**MODIFICATION WORK ORDER**

MWO MWO 9-2320-280-20-1, 6 June 1992, is changed as follows:

### MODIFICATION OF 1-1/4 TON VEHICLES

**1. PURPOSE.**

**FIGURE 1**

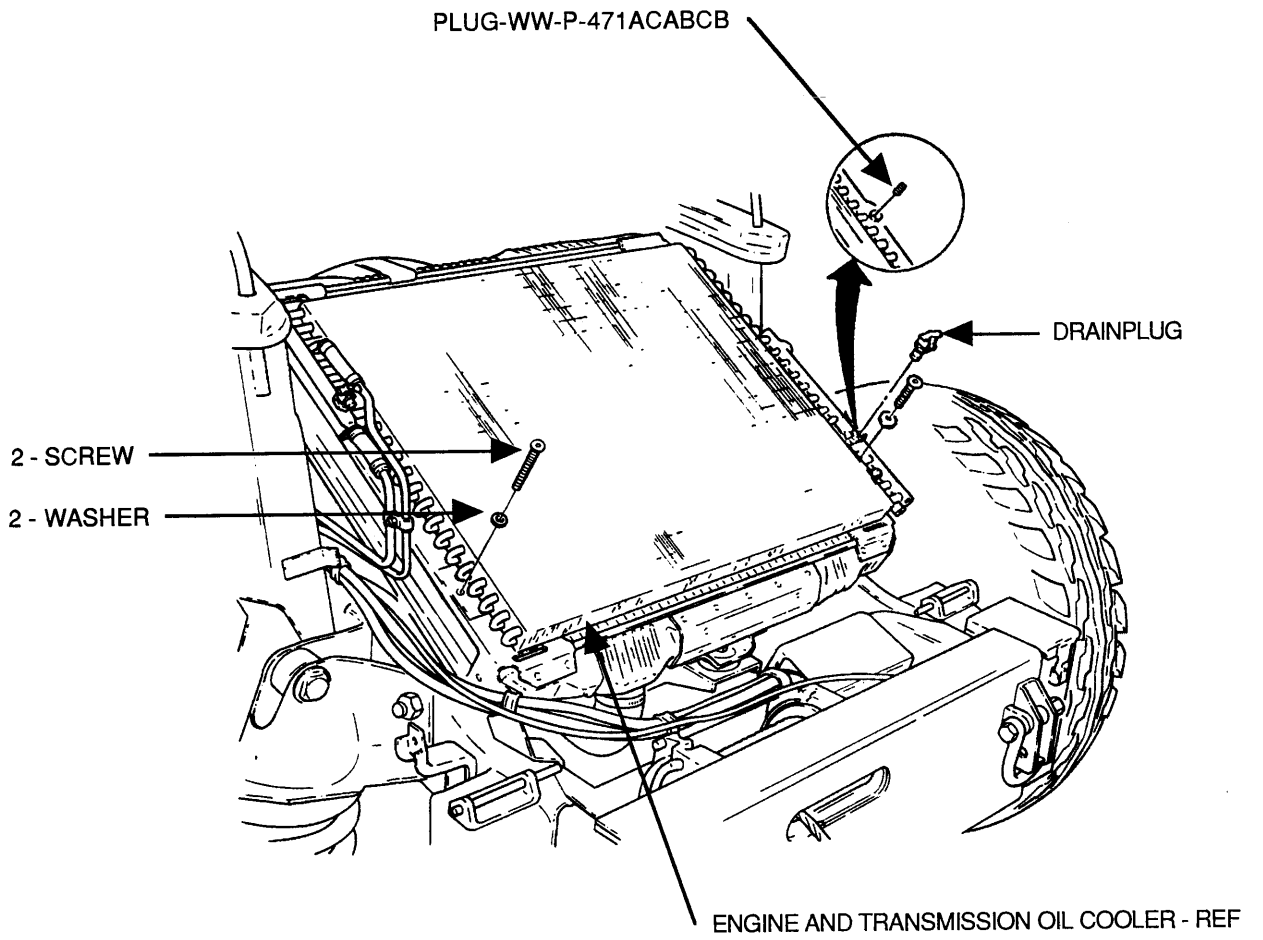
- (1) Disconnect battery ground cable. (Refer to TM 9-2320-280-20.)
- (2) Remove hood. (Refer to TM 9-2320-280-20.)
- (3) Remove left side splash shield. (Refer to TM 9-2320-280-20.)
- (4) Remove drainplug from oil cooler as shown in figure 1.

Apply sealant to threads of plug prior to installation.

- (5) Install WW-P-471ACABCB plug in oil cooler as shown in figure 1.
- (6) Remove two lower screws and washers from oil cooler as shown in figure 1.
- (7) Remove two nuts, washers, screws, and clamps from power steering hoses as shown in figure 2. Save for installation.
- (8) Remove two clamps and hose from control valve elbow and steering gear as shown in figure 2. Save for installation.

FIGURE 3

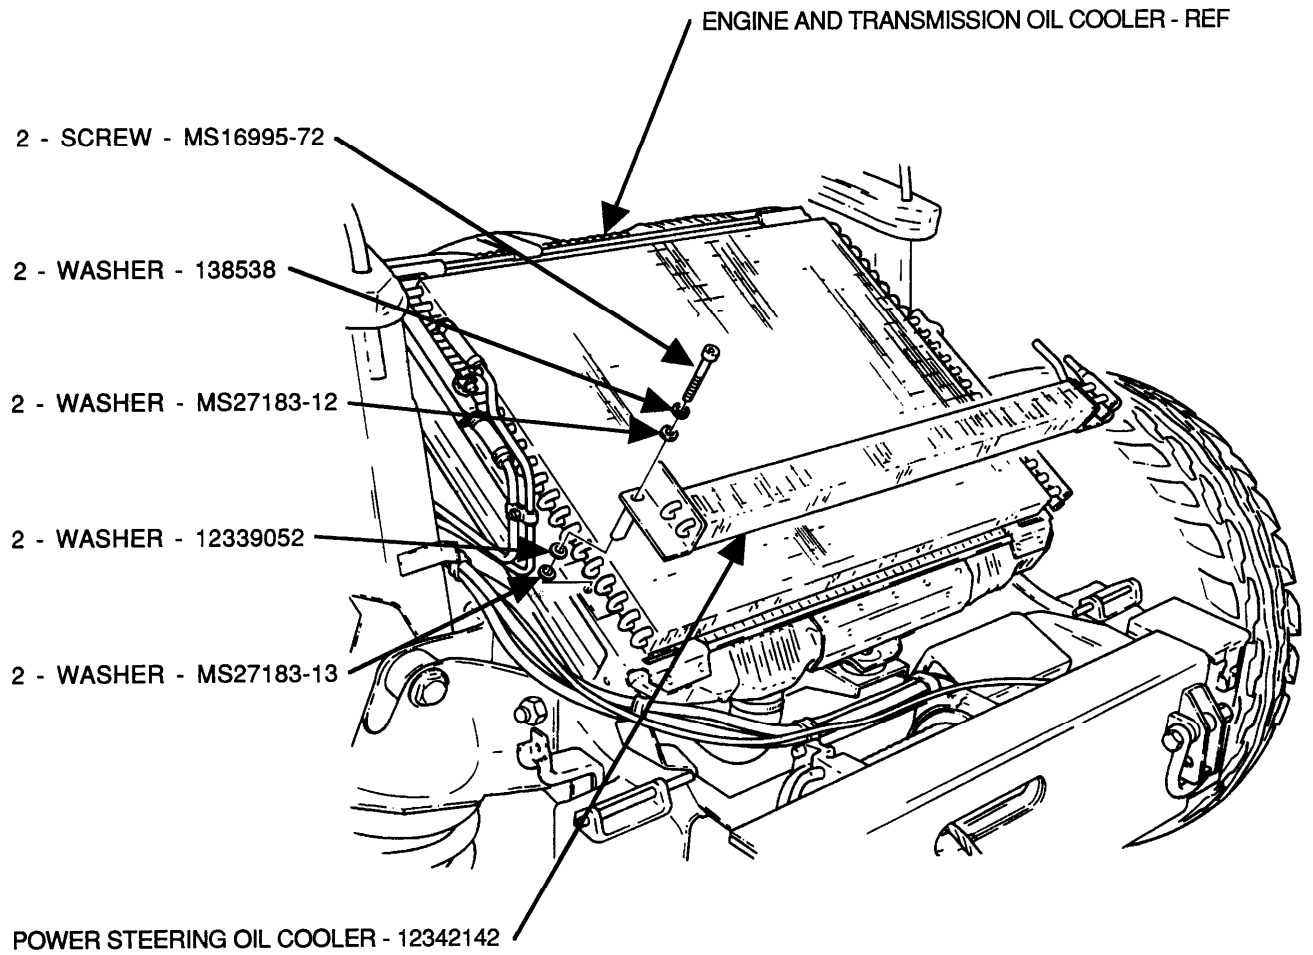
(1) Position two MS16995-72 screws, 138538 washers, and MS27183-12 washers to 12342142 power steering oil cooler as shown in figure 3.

(2) Position two 12339052 washers and MS27183-13 washers to oil cooler as shown in figure 3.

(3) Install power steering oil cooler to oil cooler and secure with two screws as shown in figure 3. Tighten screws to 12-14 lb-ft (14-18 N m).

FIGURE 4

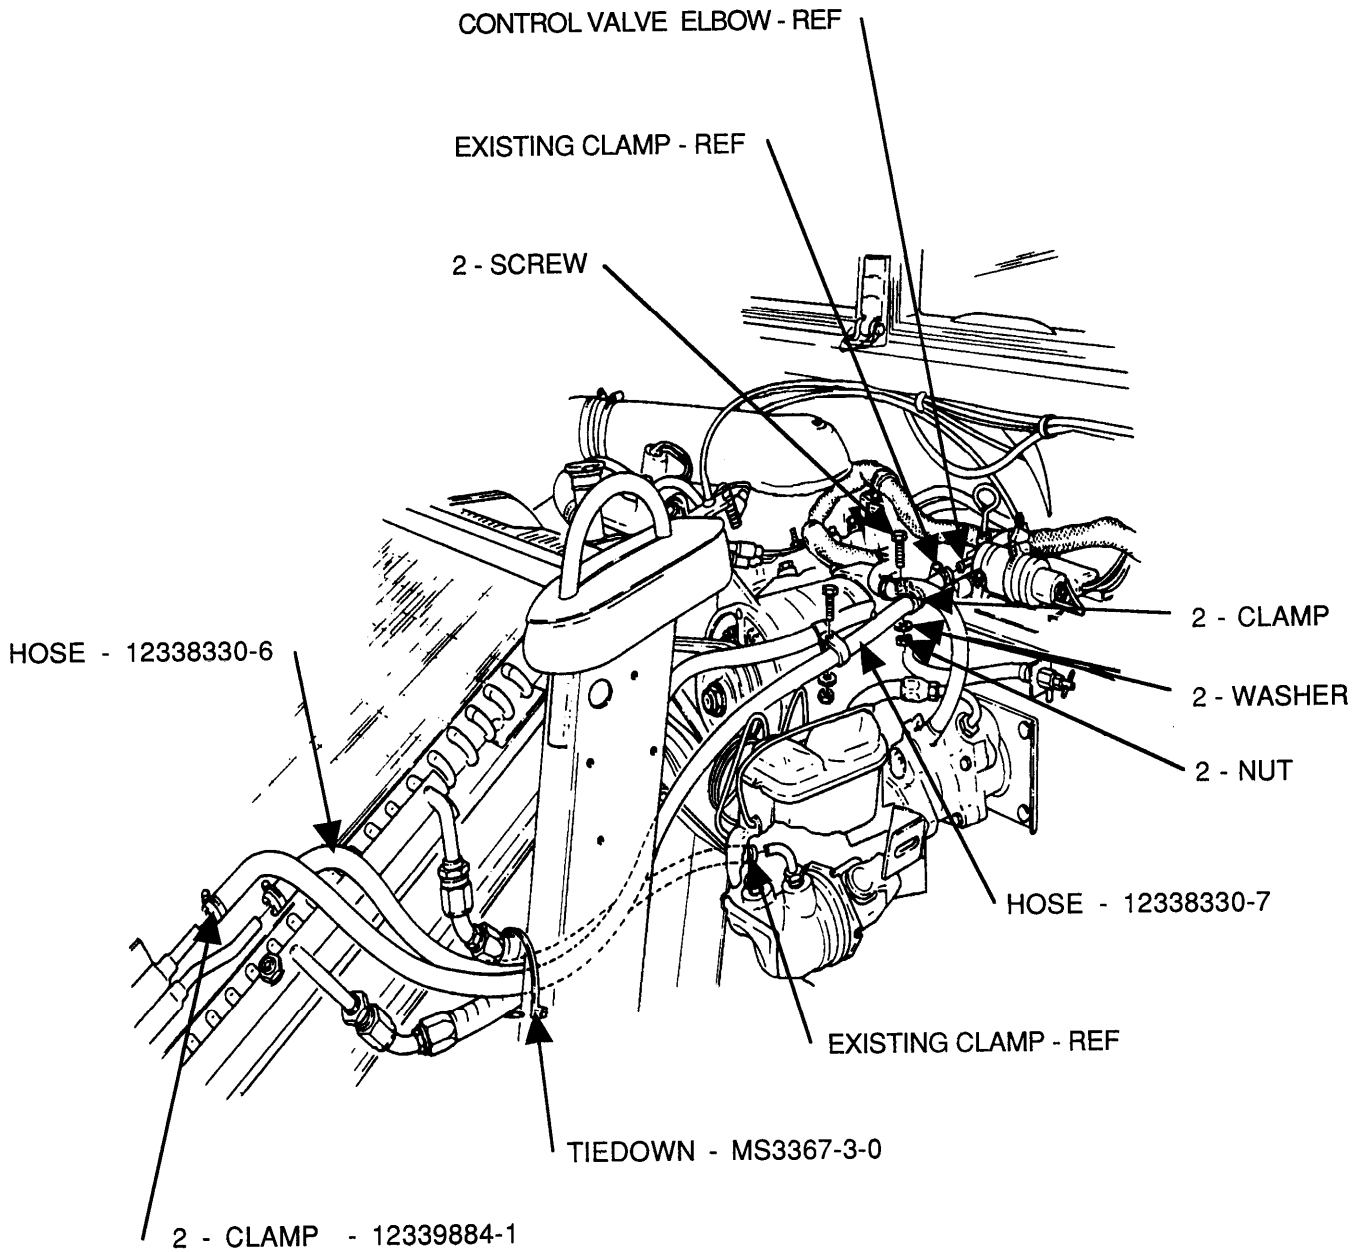
(4) Install 12338330-6 hose to power steering oil cooler and power steering gear and secure with 12339884-1 clamp and existing clamp as shown in figure 4.

(5) Install 12338330-7 hose to power steering oil cooler and control valve elbow and secure with 12339884-1 clamp and existing clamp as shown in figure 4.

(6) Position two existing clamps on hose and secure with two screws, washers, and nuts as shown in figure 4.

(7) Secure hoses with MS3367-3-0 tiedown as shown in figure 4.
